## Reviewers' Comments:

# Response to reviewers

## **Title: 3D printed biomimetic cochleae and machine learning co-modelling provides clinical informatics for cochlear implant patients**

*Fig.4c(i): The electrode-to-spiral centre distance measured for the CI electrodes in the biomimetic cochleae, compared to that measured in the human cochleae with the same CI electrode type. (P.10)*

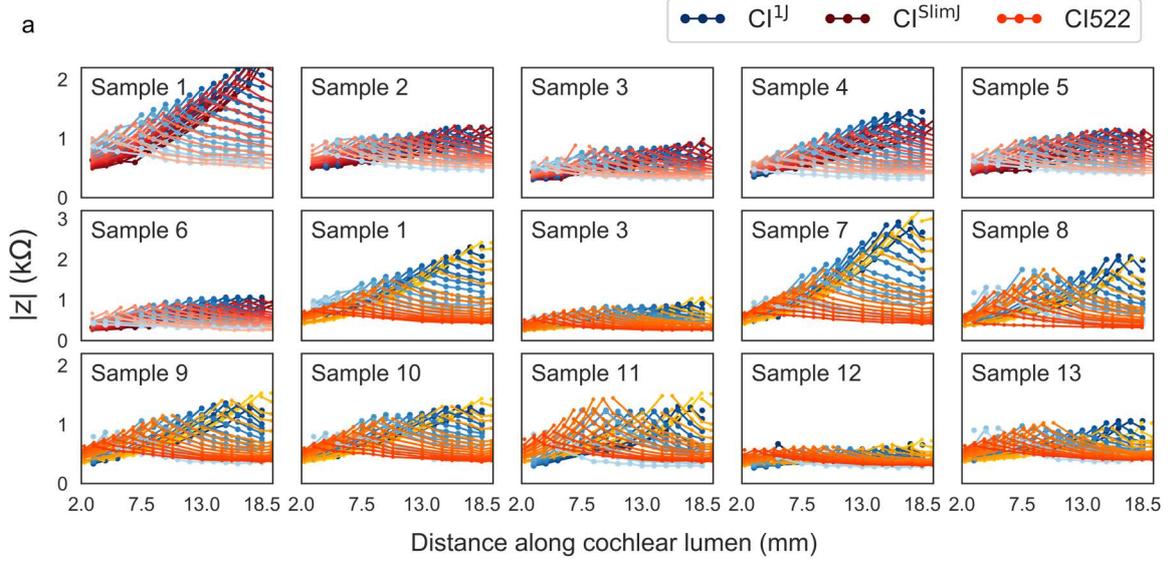
53. Supp. Fig.8 Figure title: “Electrode-to-spiral centre distance”

This figure is now moved to Fig.4c(i) in the main text (P.10) with the correct caption.

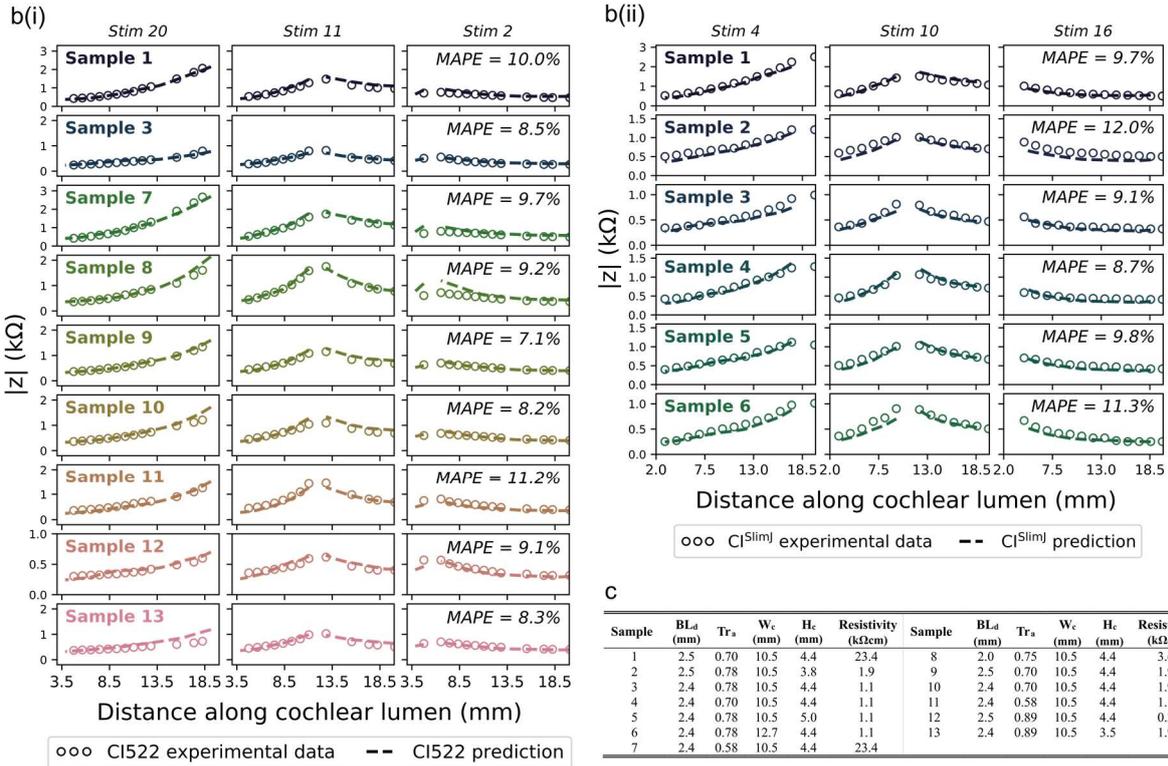
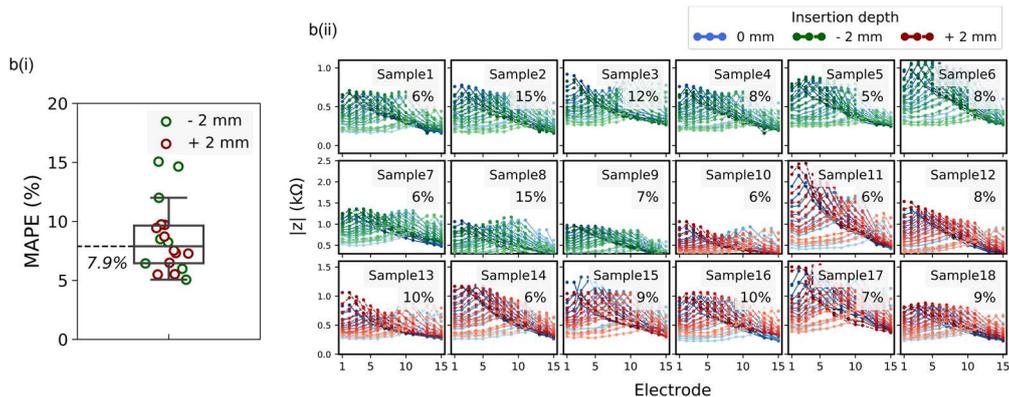
1. Ok
2. a, b. Ok c, d. I do not understand the color-coding of the new Supp. Fig. 10. The legend in a seems to be wrong? Apart from this, it is good that different electrode types have now been used.
- e. Ok
3. Perfect
4. Thank you for the clarification.
5. Not clear how the (tran-s) impedance was measured. See comment above.
6. Ok
7. Ok – sounds more realistic now
8. Ok
9. Supp. Fig. 12a: Nice figure, but “patients” (gray lines) are missing in the legend.
- Supp. Fig. 11 & 13 (full validation of forward & inverse 3PNN) are very good.
10. Ok

As discussed in comment 2, we have now included additional information regarding EFIs measured with different electrode arrays from different manufacturers. The findings in Supplementary Figs.9-13 (SI, P.20-26) demonstrate that the EFIs measured with different electrode types in the 3D printed models have a similar general shape (Supplementary Fig.10a), and 3PNN displays a good accuracy in predicting EFIs of different electrode types.

Fig.2a: Bode plot showing the impedance properties of a cadaveric cochlea in a head, and 3D printed cochlear models made of an electro-mimetic bone matrix and a hydrogel. (P.7)

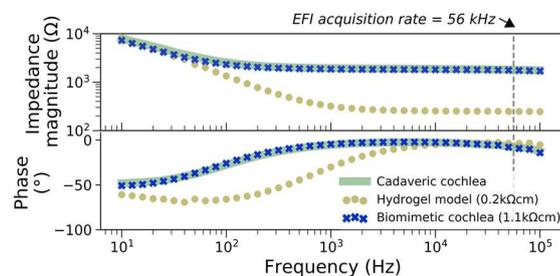
- Effect of reference electrodes in the impedance measures. Typically, EFIs are measured using a stimulating electrode and a reference electrode for the stimulation and a recording electrode and a reference electrode for the recording. Which electrodes did you use in your methods and how much were the measurements affected in your model by the fact that you do not have a head in your cochlear printed models?

Although the 3D printed cochlear models do not include the entire head configuration, our 3D printed biomimetic cochlear model exhibits a similar impedance property to the cadaveric cochlea in a head, as shown in Fig.2a. This ‘impedance matching’ ability over a wide frequency range is the key for replicating patients’ EFI profiles. The main text (P.6, Line 131) and the Methods section (P.27, Line 597) are now amended to further emphasize that the EIS measurement of the cadaveric cochlea was conducted in a head.

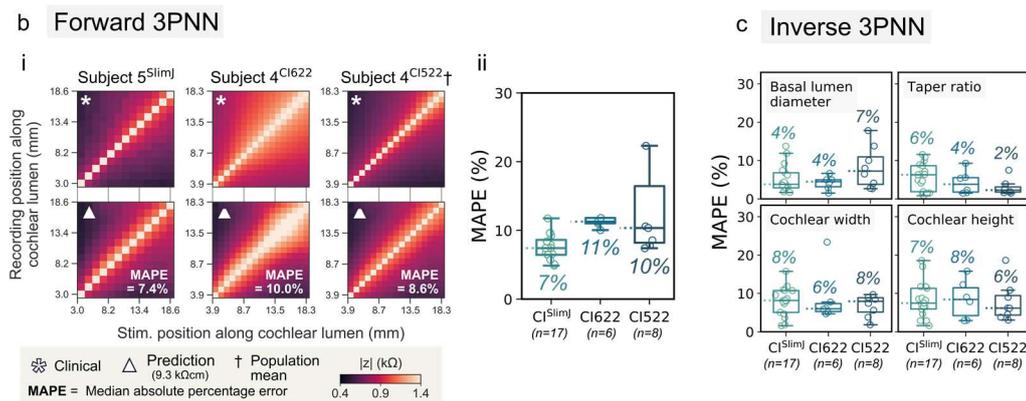
9. Supp. Fig. 12a: Nice figure, but “patients” (gray lines) are missing in the legend.  
 Supp. Fig. 11 & 13 (full validation of forward & inverse 3PNN) are very good.

The legend is now updated.

**Fig.4d:** Comparison of the mean patient EFI profile ( $n = 97$ ) and the EFI profiles obtained from 3D printed models made of hydrogel, PDMS and electro-mimetic bone matrix. (P.10)

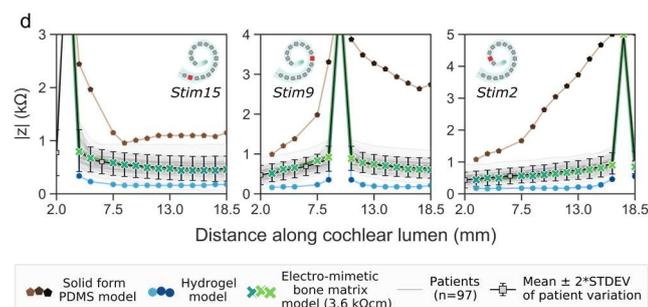
19. Fig.4d Don't need the "doubled" panels  
We have now revised the graph.

20. Fig. 4d Not sure if in these plots the impedance of the stimulating electrode is also plotted. Actually it seems that it is plotted given the large impedance at the location corresponding with the stimulating electrode. If so, why is the electrode impedance of the stimulating electrode shown here if this is not used in the models?

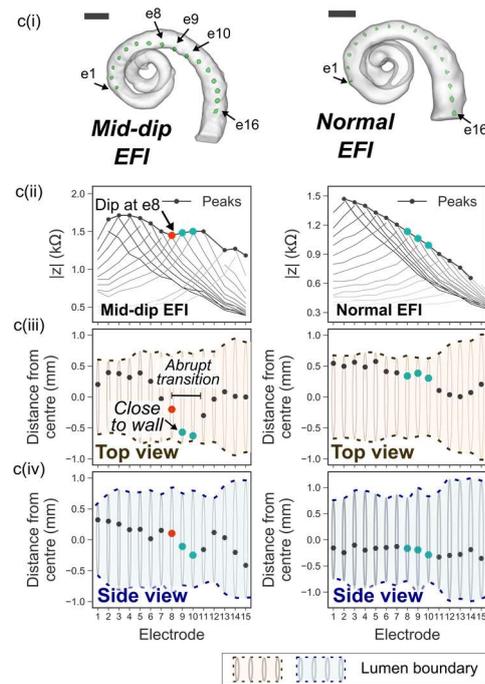
30. Fig.6d I do not understand the "electrode-distance-distance" plots in (i) as well as the plots in (iii)/(iv)  
 Fig.6d ii and iii Not clear what are the peaks. Are these the peaks of the second diagonal?  
 Peaks need to be defined  
 We apologise for the confusion. We have now improved the graph in the revised manuscript (*Fig.6c, P.18*). The 3D model in c(i) shows the 3D overviews of the locations of the electrode array in the printed lumens that is reconstructed from  $\mu$ -CT scans. To examine the electrode array locations in the 3D lumens clearly, the locations of the electrodes inside the lumen were viewed via the top view (*Fig.6c(iii)*) and via the side view (*Fig.6c(iv)*). The color-filled regions in Fig.6c(iii) and (iv) outline the boundary of the 3D printed cochlear lumens in the corresponding plane.

- The peak in Fig.6c(ii) is defined as the maximum  $|z|$  of the spread distribution at off-stimulation positions. This is now stated in the figure caption (*P.18, Lines 388-389*).

**Supplementary Fig.1:** Finite element models of **a(i)** a simplified spiral cochlea without the intracochlear membrane structures, and **b(ii)** a cochlea with the Reissner's membrane and the Basilar membrane. Scale bar = 2 mm. (SI, P.4)

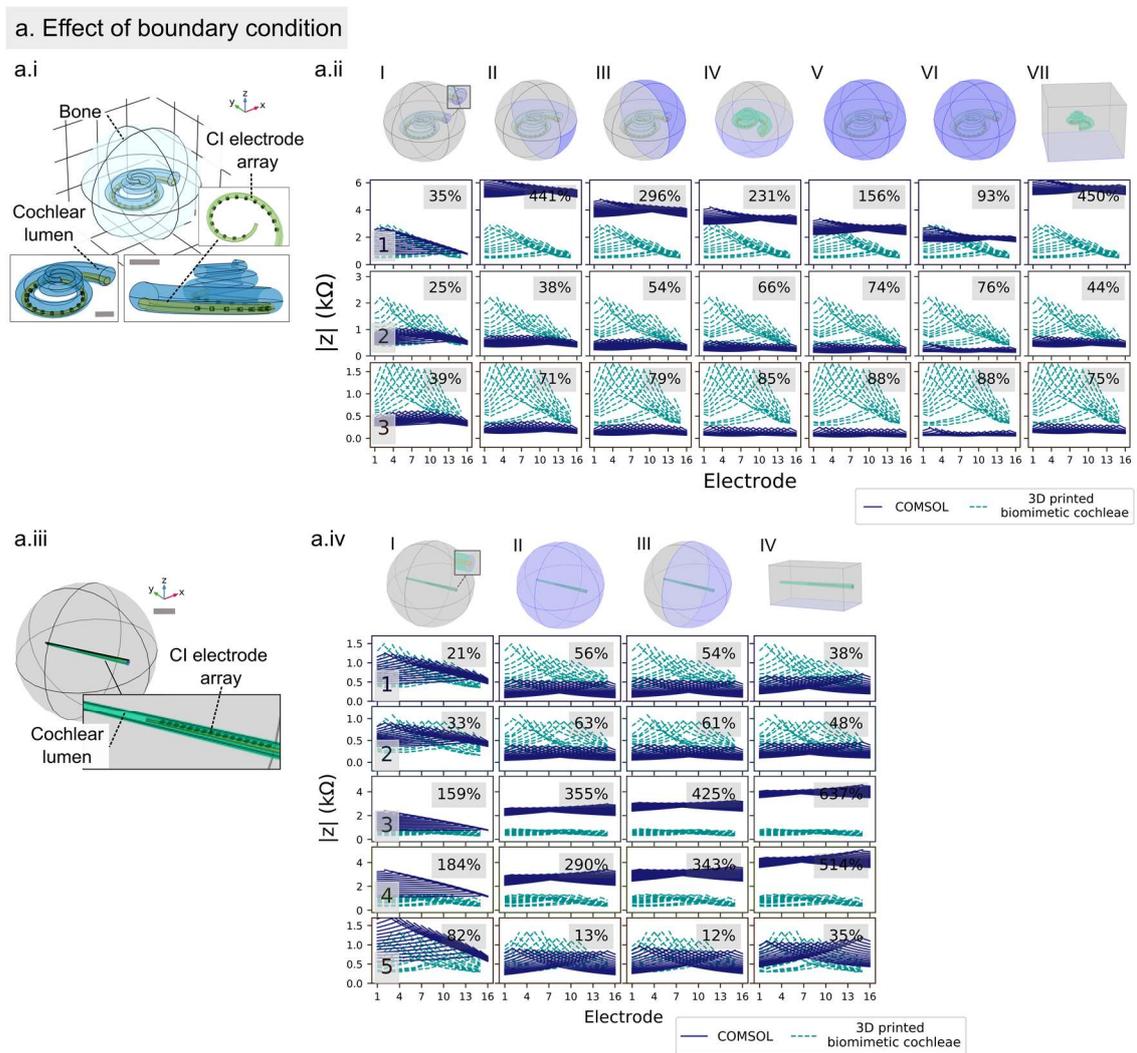
51. Supp. Fig.6e Which boundary condition is applied here? (compare Supp. Fig.7)

Thanks for the comment. Following the reviewer's suggestion, we performed additional tests to examine which boundary condition fits best with the physical (3D printed cochleae) model cases. In Supplementary Fig.1a(ii), we compare the experimental EFIs of

five 3D printed cochlear models with the simulated EFIs obtained from our COMSOL FEM built with the same model descriptors. These results show that the ground placements affect the EFI result significantly. Although placing the ground at the lumen opening in the COMSOL model (condition I) yields the EFI most matching the physical measurements compared to other types of placements, the resemblance is still not ideal. When performing the same comparative study for a linear geometry, as shown in Supplementary Fig.1a(iv), the MAPE can be  $> 180\%$ . Although our comparative results can be used to guide the boundary condition choice in FEM, the real implication of these results is to confirm the advantages of using a physical model when the modelling parameters or the physical empirical laws are undetermined and complex. Our 3D printed cochlear models can replicate clinical EFIs with high fidelity, and are robust to changes in measurement configuration. This is now pointed out in the Discussion (P.20, Line 439-441) and Supplementary Information (SI, P.4-6).

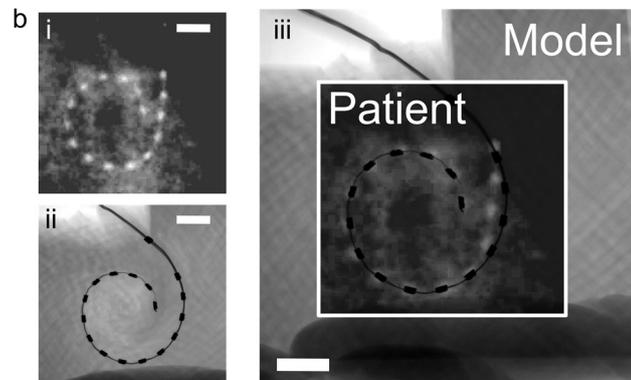
My concern is that later (lines 188-190) we are told that intracochlear structures (e.g., basilar membrane) are not modeled. Does the presence of intracochlear structures not affect electrode insertion? If it does not, please provide evidence.

2- Thanks for comparing the final insertion in 3D printed model and in one patient (Supp. Fig 7.b). Please comment on having n=1 comparison. Also, it would be great if the authors could show this comparison from other angles as well. In the presented views, it is unclear how far the electrode is placed away from the basilar membrane. For example, Figure 4 b(ii) shows the positioning of the electrode in printed model from a side view, which indicates the trauma caused to basilar membrane due to intrascalar penetration, if such insertion was made in a patient. It would be great to include more of patient-model comparison and provide quantitative analysis of such comparisons.

We acknowledge the reviewer's concern here. In our revised manuscript, we compared the positions of the electrode array in a patient's cochlea and in a 3D printed model that has similar geometric descriptors, as shown in Supplementary Fig.7b. Both the 3D printed

model and the patient's cochlea were implanted with the same type of electrode array (CI<sup>SlimJ</sup>). Though our 3D printed models do not capture the intracochlear structures, the positions of the electrode array in the patient's cochlea and in the 3D printed model are almost identical, with an angular insertion depth  $\sim 420^\circ$ . This finding is now added in the Results section (P.11, Lines 233-238).

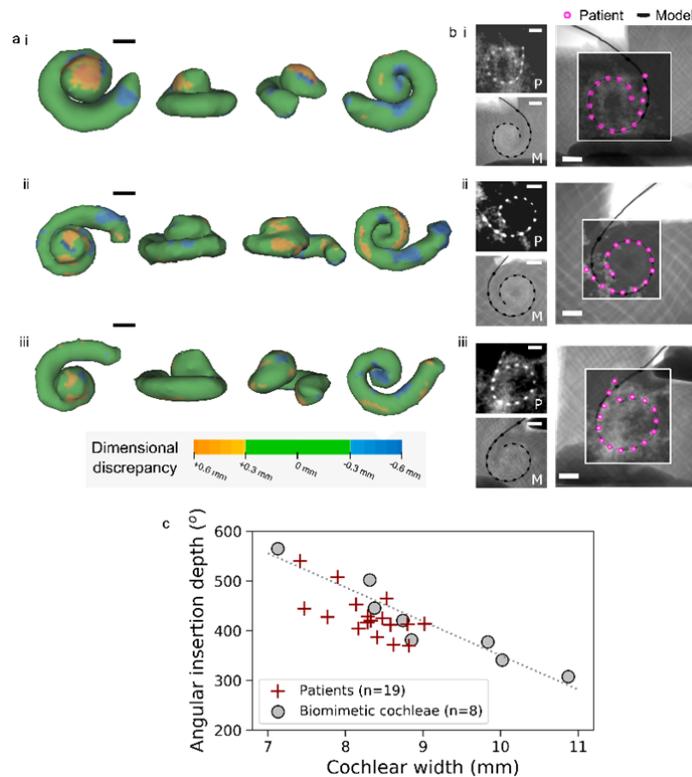
An error map as in Figure 8 of that paper would be useful.

We acknowledge the Reviewer's comment. We have now provided additional imaging examples on the comparison of the CI insertion depths in 3D printed models and in patients' cochleae ( $n = 3$  in total). The figure (*Supplementary Fig.7b, SI, P.16*) shows that the insertion depths are satisfactorily matching when their geometrical descriptors are similar. In addition, *Supplementary Fig.7c (SI, P.16)* compares the insertion depth in the 3D printed models and in the patients' cochleae that have different values of the geometrical descriptors. The figure reveals that the 3D printed models result in a similar correlation between the angular insertion depth and the cochlear width, to those seen in patient's ( $n > 8$ ).

We have now provided the color-encoded error maps and additional results to examine the dimensional discrepancy between the patients and the models that have similar geometrical descriptors using AutoDesk RaCap Photo (Supplementary Fig.7a, SI, P.16). In the analysis, we defined a tolerance level of  $\pm 0.3$  mm, as 0.3 mm is the mean pixel size of patient's CT scans. The figure shows that most region of the 3D volumes up to 1.5 cochlear turn (encapsulates the angular insertion depth in patients) has a dimensional discrepancy within the tolerance level, despite the alignment of the 3D volumes is not optimised here. This is now stated in the Results (P.11, Lines 238 - 242).
